Aiea Stream
Flood Control

REVISED
ENVIRONMENTAL IMPACT STATEMENT
FOR THE
AIEA STREAM
FLOOD CONTROL PROJECT

Aiea, Oahu, TMK: 9-9-05

- A. Agencies and Organizations Consulted for the EIS
- B. Comments and Responses to the EIS

AIEA STREAM FLOOD CONTROL
FIGURE 4
 REPRESENTATIVE
 SECTIONS
 SCALE: 1 INCH = 10 FEET

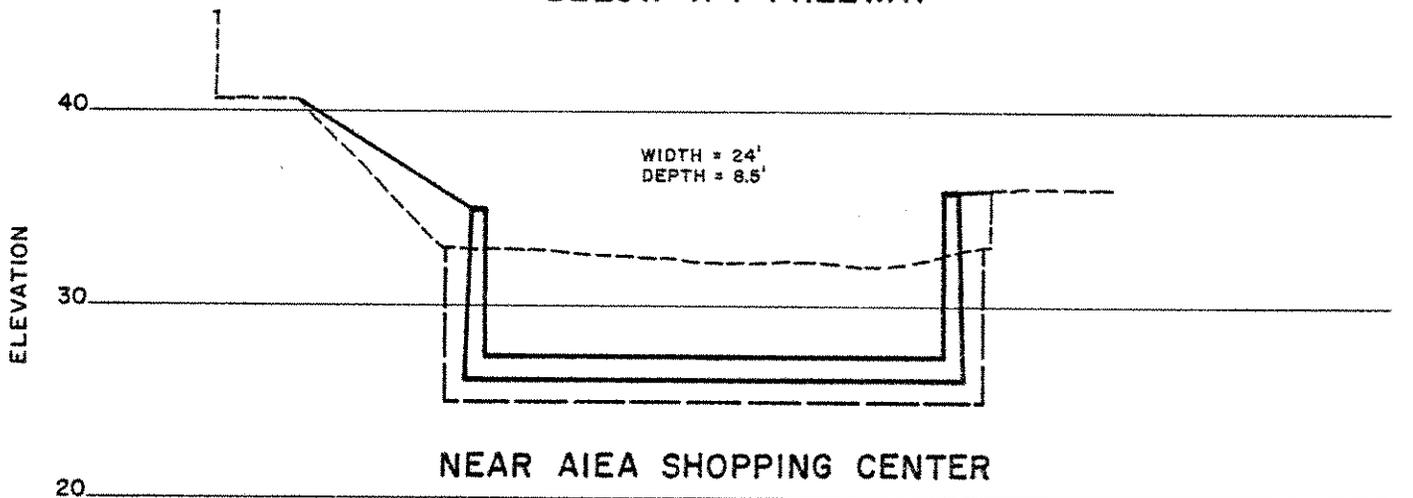
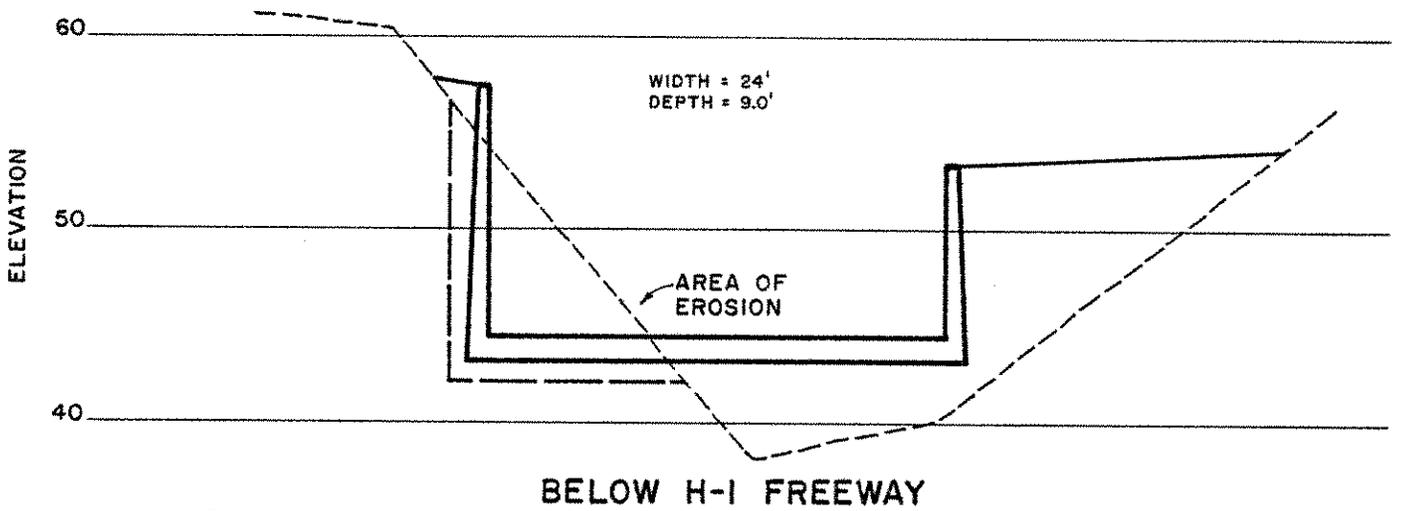
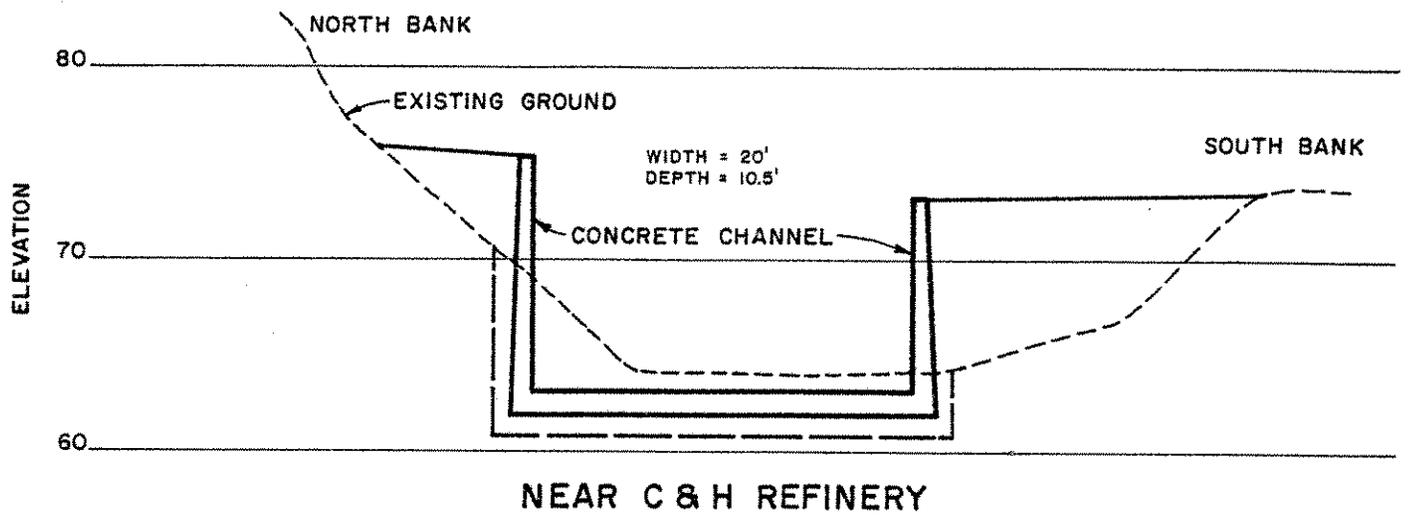
We note that Figure 4, Representative Section, indicates that there will be fill material introduced into the stream; therefore, a Department of the Army Permit under the authority of Section 404 of the Federal Water Pollution Control Act Amendments of 1972 will be required. The permit application for the project should be submitted in a timely manner to avoid unnecessary delays.

The proposed action will require a Department of the Army Permit for Activities in Waterways (Section 404 permit). The necessary forms and supplemental data will be submitted with the Revised EIS.
